December 10, 2009
E-28034

Subject: Transnuclear, Inc. (TN) Application for the TN-40 Transportation Packaging for Spent Fuel, Revision 3, Docket No. 71-9313, TAC No. L24106

Reference: Letter from Meraj Rahimi (NRC) to Robert Grubb (TN), "Second Round Request for Additional Information for Review of the Model No. TN-40 Transportation Package," dated January 29, 2009

TN-40 RAI No. 2 – RAIs and Associated SAR Pages

Figure 2-8.1 – TN 40 Shell Flange, Nodal Stress Intensity Distribution for A12 (Cold)

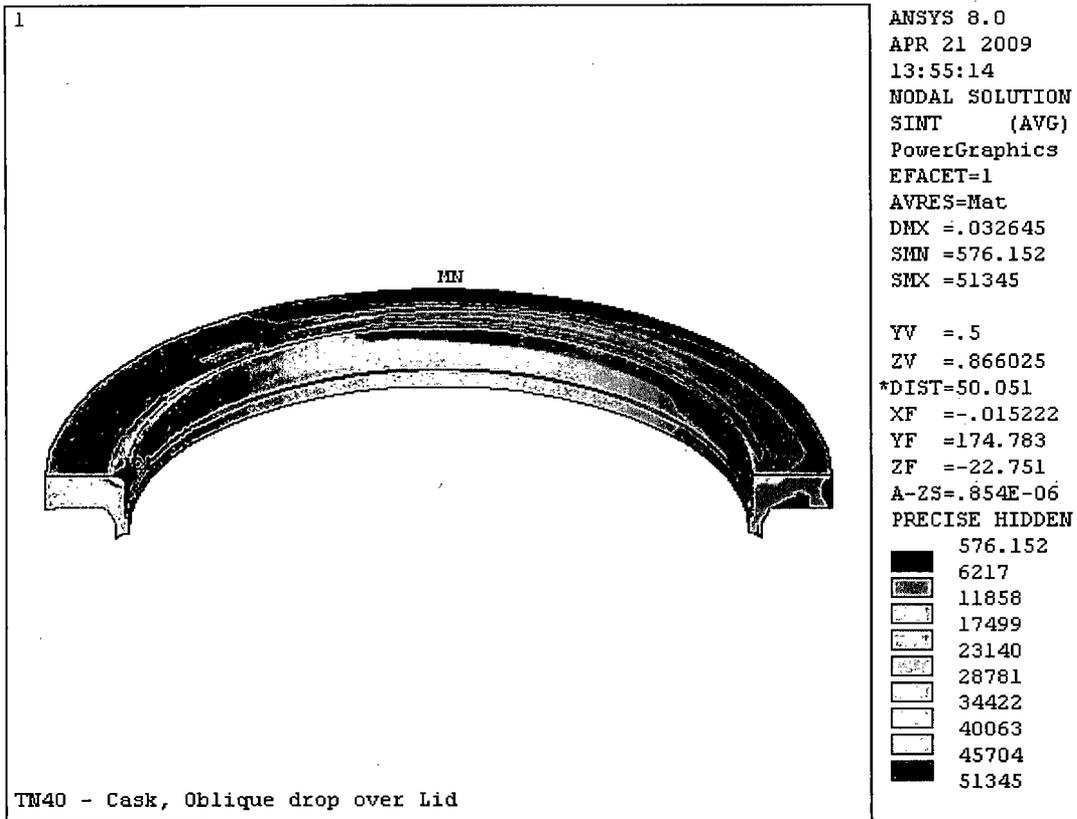
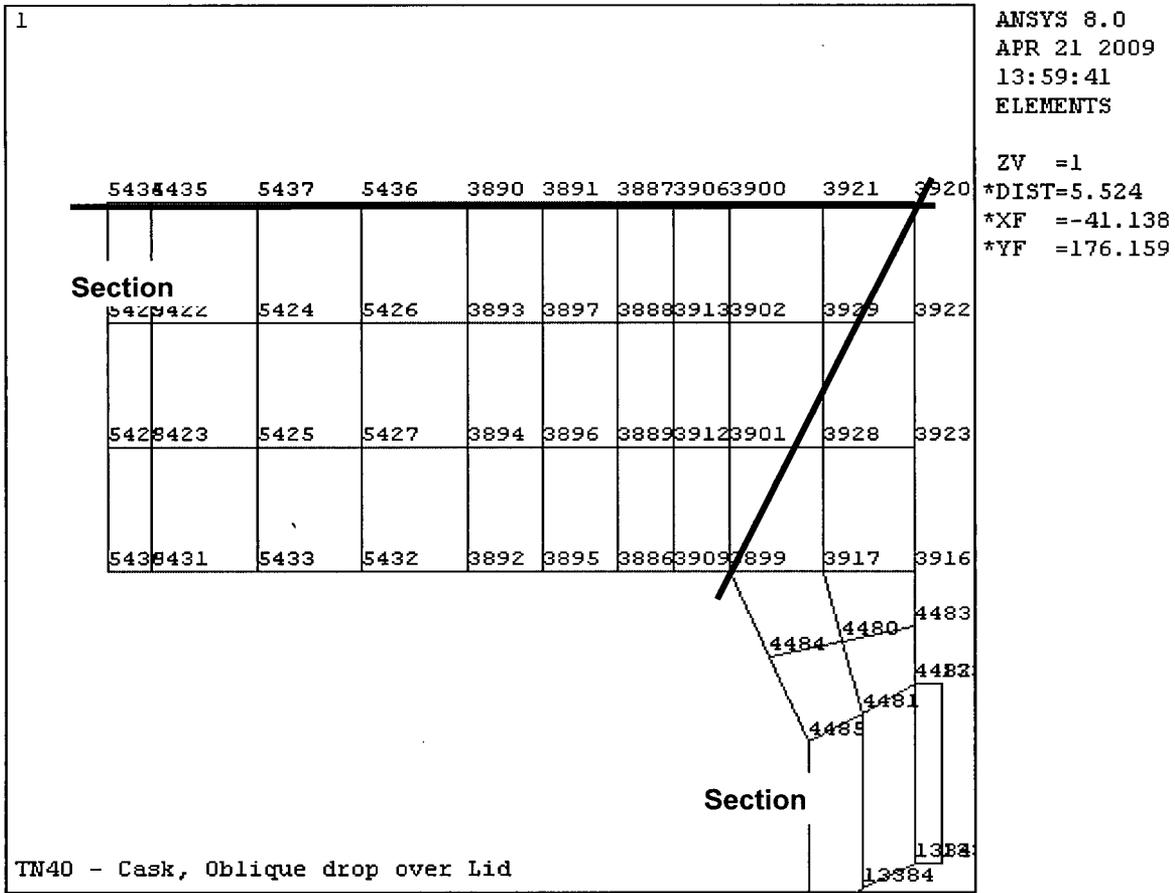
2-8 Verify that the cross section is appropriately selected for evaluating the maximum stress intensity for the containment boundary shell flange for the load combination Case A12, which includes the cold, 30-ft slapdown drop event.

The nodal stress intensity distribution in the shell flange for load combination Case A12 is shown in Figure 2-8.1 below. This load combination includes the cold, 30-ft slapdown drop on lid event. The figure shows that the maximum nodal stress intensity of 51.35 ksi occurs at node number 3920 located at the flange inner diameter corner. Flange node numbers at a section through 3920 are shown in Figure 2-8.2. The two cross sections from the highest stress intensity node 3920 shown in Figure 2-8.2 are considered bounding. One cross section is defined by nodes No. 3920 and No. 5434 and other cross section is defined by nodes No. 3920 and No. 3899. Stresses are linearized at both of the cross sections. The stress linearizing details at these two cross sections is given in Tables 2-8.1 and 2-8.2 below. A summary of stress intensities is given below:

It is seen from above that cross section 1, defined by nodes No. 3920 and No. 5434, has the higher stresses and was therefore appropriately selected for reporting shell flange stresses in SAR.

Figure 2-9.1

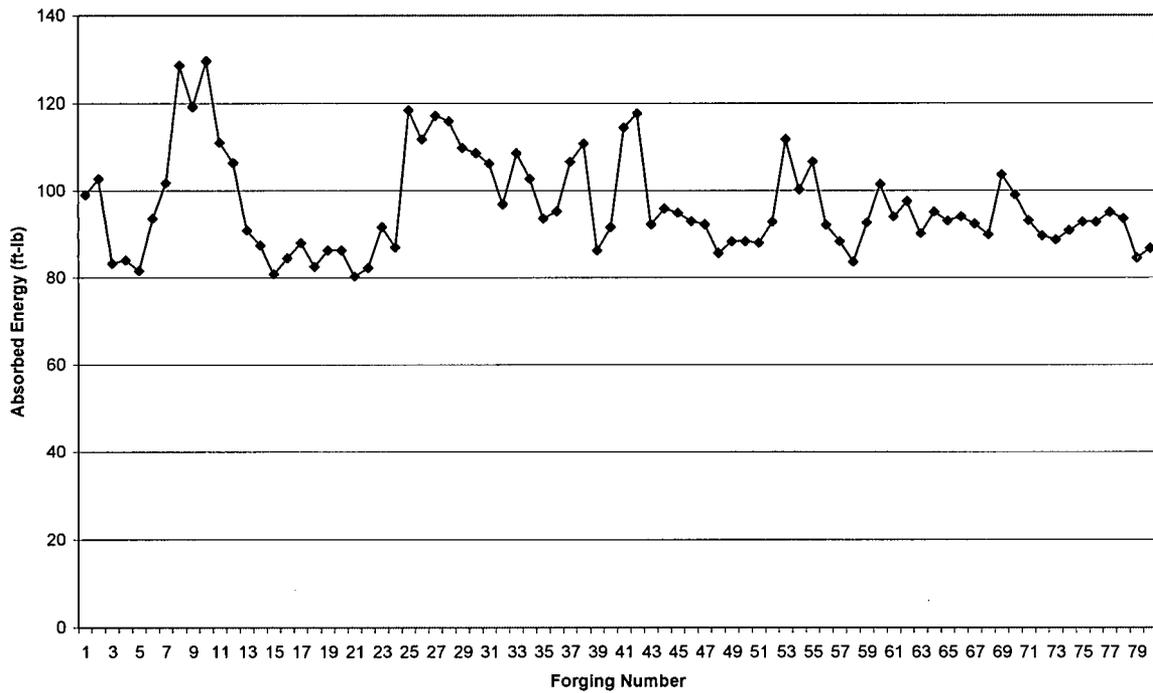
- 2-9 Provide justification that the testing, using a limited combination of potential base metals, filler materials, and weld techniques (2 tests), bounds the worst case fracture toughness expected from all potential combinations of these three parameters. Explain why TN fabricators chose the combination of weld processes, electrodes, and base material presented in the table to demonstrate the toughness of the weld and heat affected zone (HAZ). Defend why the table data are representative of all other possible combinations which can be used, or are these data the best case scenario?

The average test result for the forty TN-68 Shield Shells at -20°F was 96.6 ft-lb with a standard deviation of 11.3 ft-lb. The TN-68 results are both much higher (over five times) than the TN-40 requirement of 18 ft-lb and very consistent. 18 ft-lb equals the average TN-68 result minus nearly seven standard deviations. These results strongly support the conclusion that the fracture toughness properties of the TN-40 Shield Shells exceed the minimum required by a margin which can safely accommodate any realistic variations in chemical composition and physical processing as well as the effects of welding.

Heat-to-heat variation in stress-strain diagram for 304 stainless steel tested at (a) 24°C, (b) 93°C, (c) 204°C, and (d) 316°C.

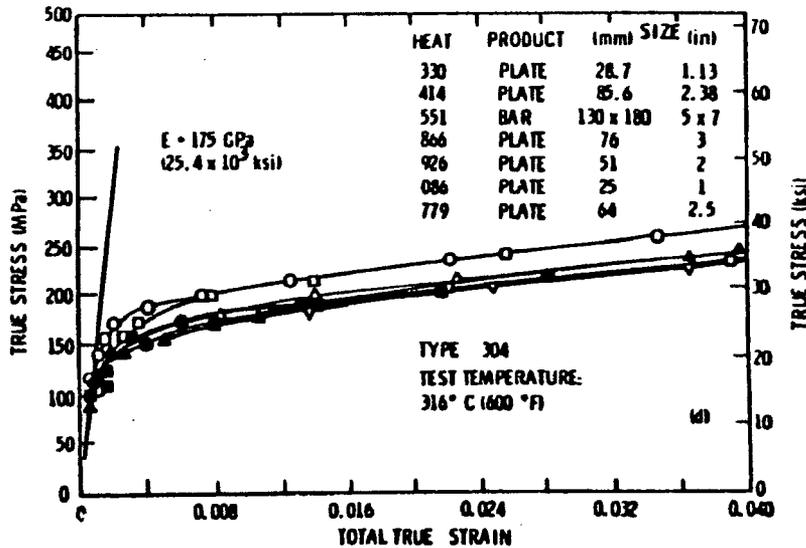
- 2-12 On page 2.10.5-4, provide data or reference to show that a 5% strain-hardening rate ($E_p/E = 0.05$) is conservative for the bilinear stress-strain curve implemented for both the SA-240 Type 304 SS steel and SB-209 Type 6061-T651 aluminum alloy plates in the basket non-linear finite element structural analysis.

Using a 5% strain-hardening rate, which is greater than those shown in the figure above, is conservative because it will yield higher stresses. The maximum stress in the SS boxes is less than 30 ksi (~201 MPa); thus the material remains in the low plastic strain region where the effect of the strain-hardening rate is minimal.
